ADDENDUM No. 1

RFP No. 19-12

WWTP Headworks Improvement Project

The following questions and answers are provided for the Request for Proposal for WWTP Headworks Improvement Project, RFP No. 19-12, on which proposals will be received on/or before the date and time listed above.

NP 3102 MT 3~ 463

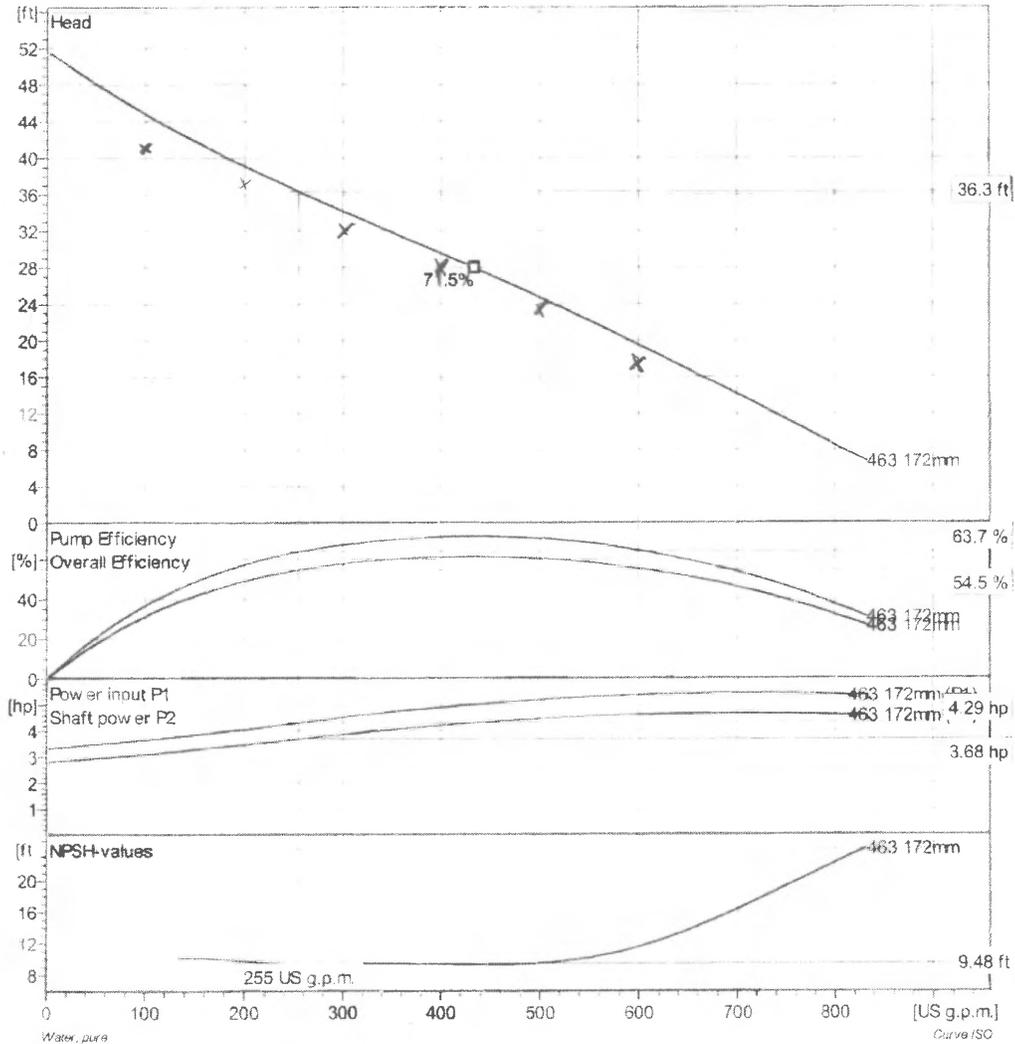
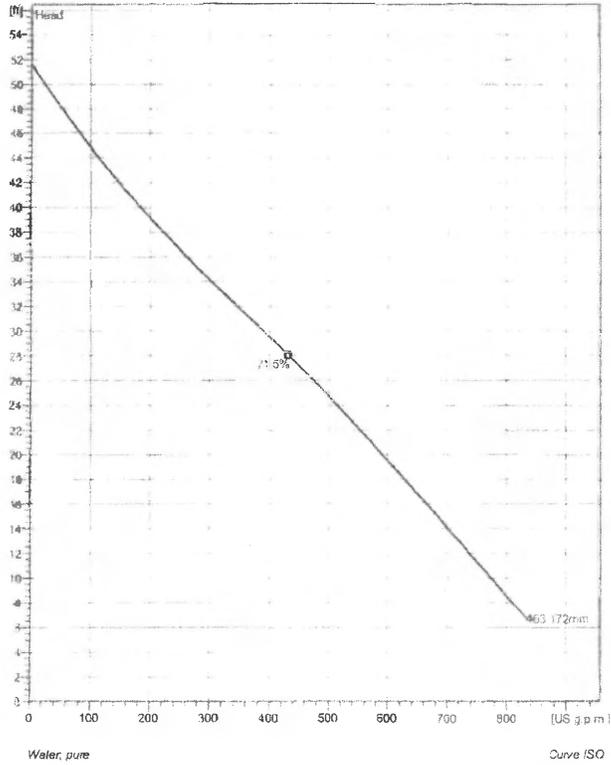
8. Can the City provide information regarding the grit pumps used to convey flow to the Eutek units?

RESPONSE: Grit pump information is attached. The WWTP uses a combination of Flygt and KSB submersible pumps. Two Flygt pumps were installed in the North Channel in 2017 after two KSB pumps failed. Two KSB submersible grit pumps are in the South Channel. Grit pump information will also be uploaded to City's Liquid Files FTP site.
